## PLANNING REPORT

# Planning and Zoning Commission

## Dublin Senior Living 26-015INF

# 26-015INF - Dublin Senior Living

Proposed Site Plan

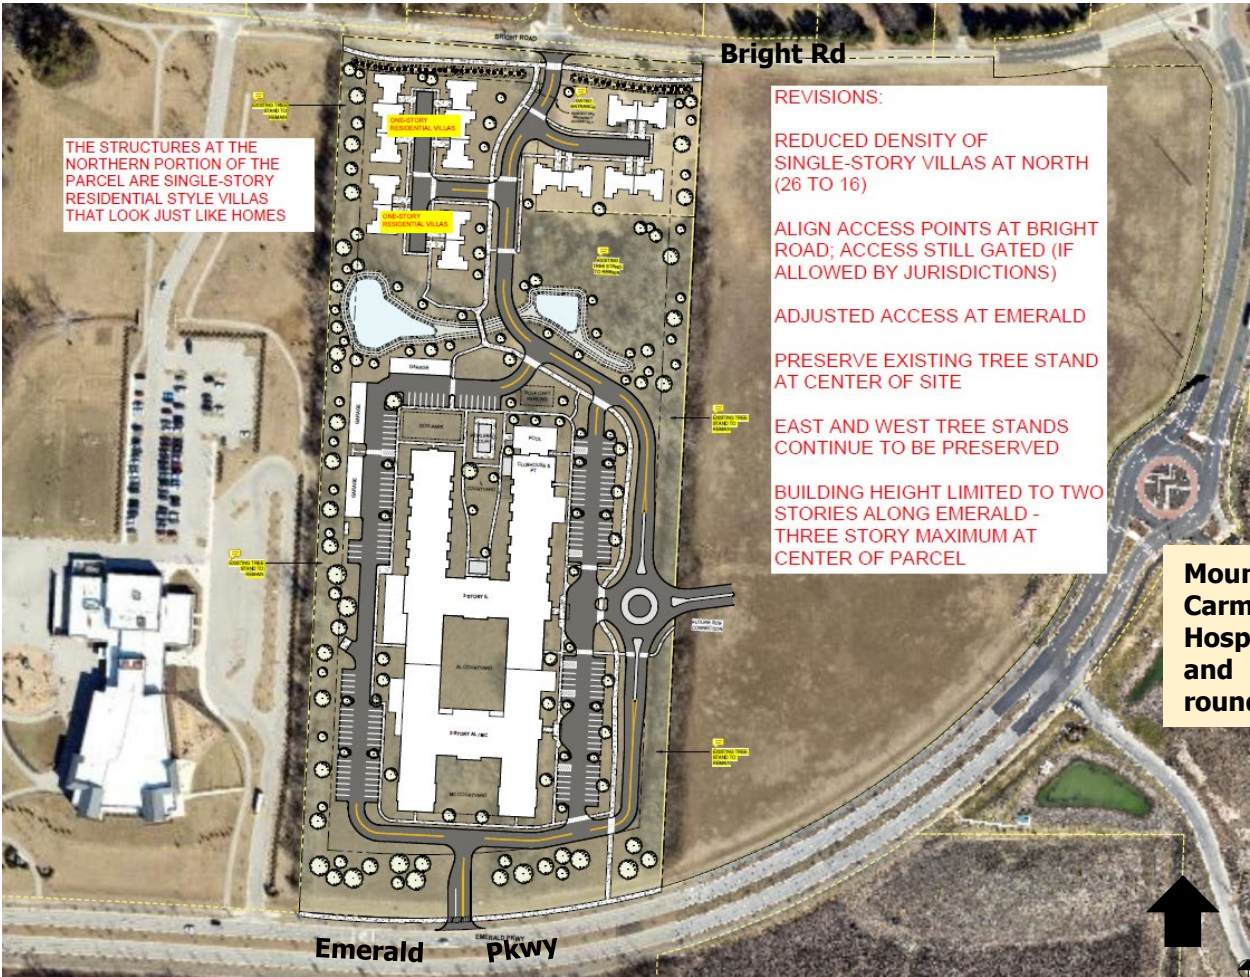
This request shows a 2-3 story independent living, assisted living, and memory care building perpendicular to Emerald Parkway in the south portion of the site, with primary access directly onto Emerald Parkway. Parking is on three sides of the building, with the Emerald Parkway frontage being reserved for access. Covered, separate parking garages are shown to the northwest of this building. The north side of the property, across the ephemeral stream, shows residential villas, plus access drives. Access on this side of the property is on Bright Road, opposite the existing Macbeth Drive; however, a north-south private interior roadway connects through the site. This northern access is shown as “gated if permitted”: see the transportation discussion below. A private roundabout is shown connecting to the parcel to the east.

Property line tree rows are shown to be maintained, as is the bulk of the tree stand south of the existing house site. The center tree row is removed. The ephemeral stream is used as a stormwater detention feature.

Regarding the main building's horizontal massing, staff believes that there should be a stronger building presence on Emerald Parkway from the south façade. This could be achieved by shortening the "legs" of the southern **H** of this building. Conversely, the length and resulting massing of the east and west elevations will need some architectural relief. Alternatively, it might be worth considering reversing the vertical massing of the building components placing the three-story portion along Emerald Parkway and transitioning to two stories to the north. This could help push the mass further away from the nearby residential uses while enhancing the presence along Emerald Parkway.

The proposal shows preservation of the exterior tree rows, most of the tree stand, and accommodation of the ephemeral stream as part of the stormwater ponds. The central tree row would be removed. Should this project move forward, a Tree Preservation Plan would be required at PDP: tree roots should be protected by adequate setbacks, taking into account buildings, parking, construction, and utility impacts.

For Emerald Parkway, a minimum 100' setback is shown on the site plan, as anticipated. This edge is only shown as grassed and treed at this early stage, although a sidewalk/shared-use-path is shown. The Emerald landscape will have to be intensified to

Parking on the east side of the property will be visible for some time into the future, even if the east tree row is preserved. Parking is meant to be hidden from view from Emerald Parkway, and this should be designed into the site at future planning stages.

The ephemeral stream and related trees are shown on the plan, although development of the anticipated focal feature is not yet suggested. The City will be anticipating something memorable and open to the public. The placement of the garages directly along, and closest to, the stream and focal feature detracts from this vision and should be adjusted as the project progresses.

Staff questions the need and location of the private roundabout shown on-site: it might be moved to the north at the bend of the private road to create a better configuration for the parcel to the east. Consideration of a **T** intersection might make more sense and be less costly to develop and maintain.

*Site superimposed on SAP*

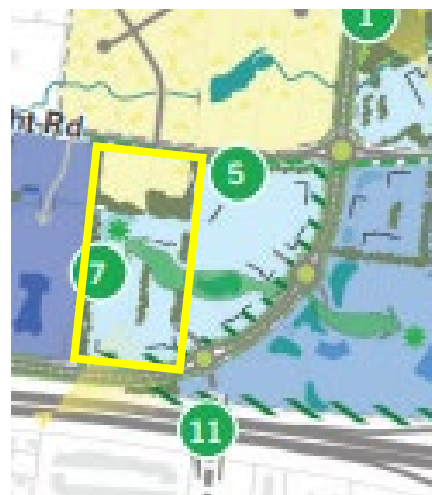
The subject site is located within the Bright/East Emerald subarea of the Emerald Corridor SAP. Land uses are shown as Neighborhood Office in the south and Single-Family Residential in the northern portion of the site. The intent of this area is to protect and buffer existing residential areas, encourage open space and pedestrian connections, improve traffic circulation, and maintain high-quality development standards. In the SAP, all existing tree rows are preserved, and the ephemeral stream is shown as a larger local feature (green arrow) with terminal focal point ending in this

Southeast of the site, the planned I-270 overpass (#11 on SAP, above) will connect with Emerald Parkway at a roundabout. While the timing and exact location of these facilities are not yet known, the applicant is aware of this improvement.
